Planning/Zoning Application

RE: Site Plan Review for the New Robinson Metal Loading Docks, Pavement, and Screened Gas Tank at 2121 American BL
(Parcels WD-1040 and WD-1041-2)

Thank you for the site plan for the New Robinson Metal Loading Docks, Pavement, and Screened Gas Tank at 2121 American BL. The City of De Pere staff reviewed the site plan on July 2, 2024, and recommended approval with two conditions that may need to be addressed prior to requesting occupancy permits:

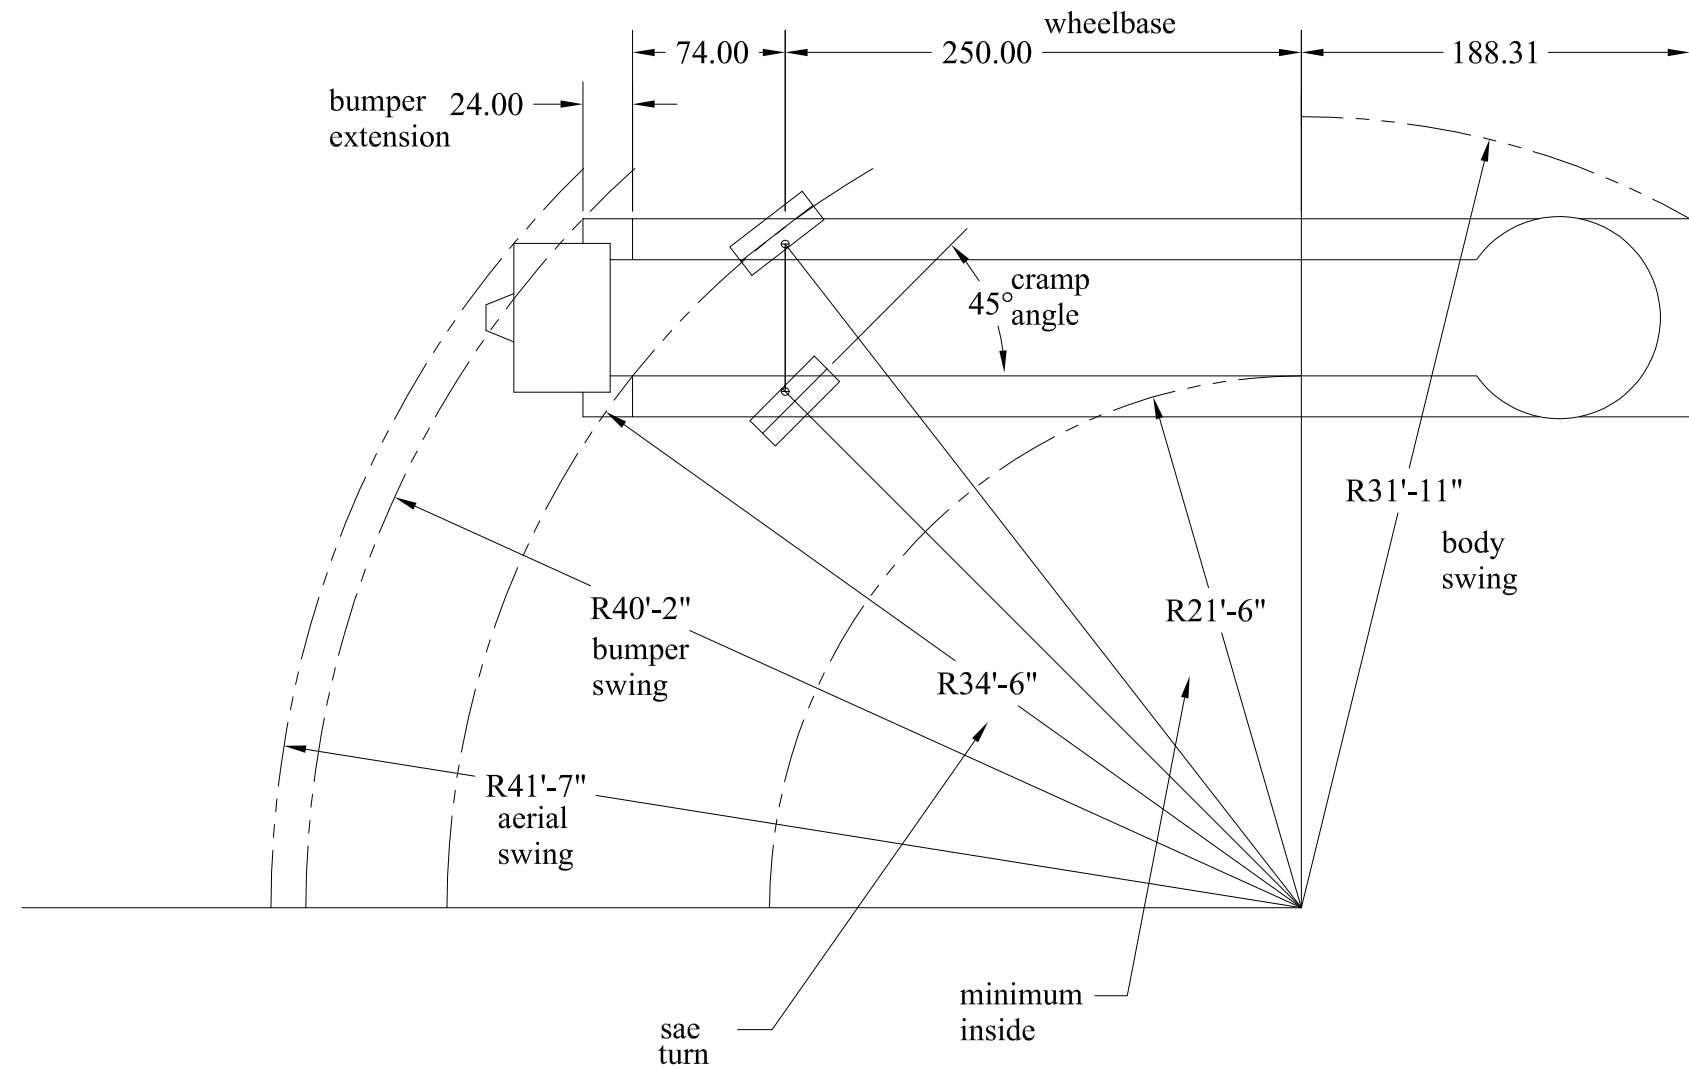
- Site Plan review is for Phase 1 part of site plan only (loading docks existing pavement replacement on north side of building, new pavement adjacent to north side of building, and screened gas tank on east side of building). Future Phases 2 and 3 are not part of the review and need to be submitted as a separate site plan(s) with separate fee(s).
- To provide adequate fire protection, ensure access road supports aerial truck weight and turning radius.
